Product Change Notification

Product Group: OPT/Tuesday September 1, 2026/PCN-OPT-1495-2026-REV-0

IL41x, BRT2x, VO41xx, VO306x OptoTRIACs green production line transfer

DIP-6

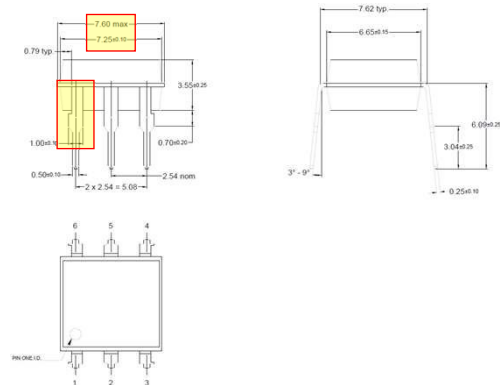
Note: major changes are the package length and the lead shape form

SMD-6 (option 9)

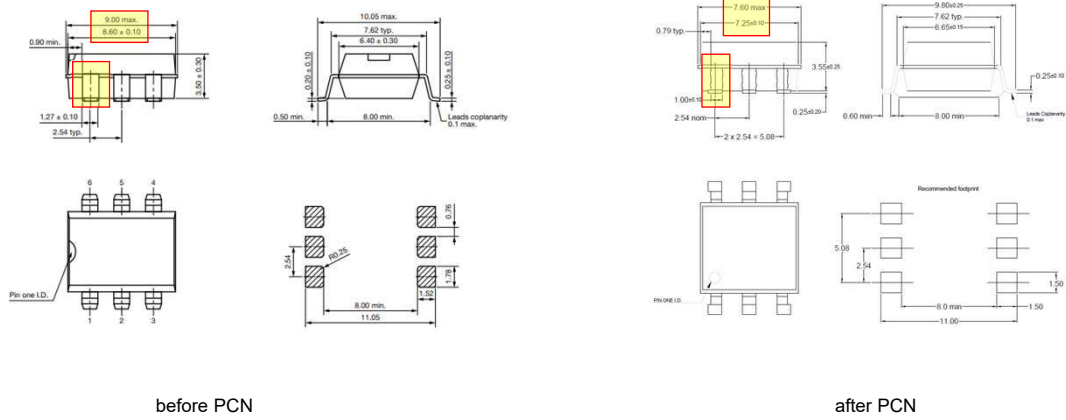
Note: major changes are the package length and the lead shape form
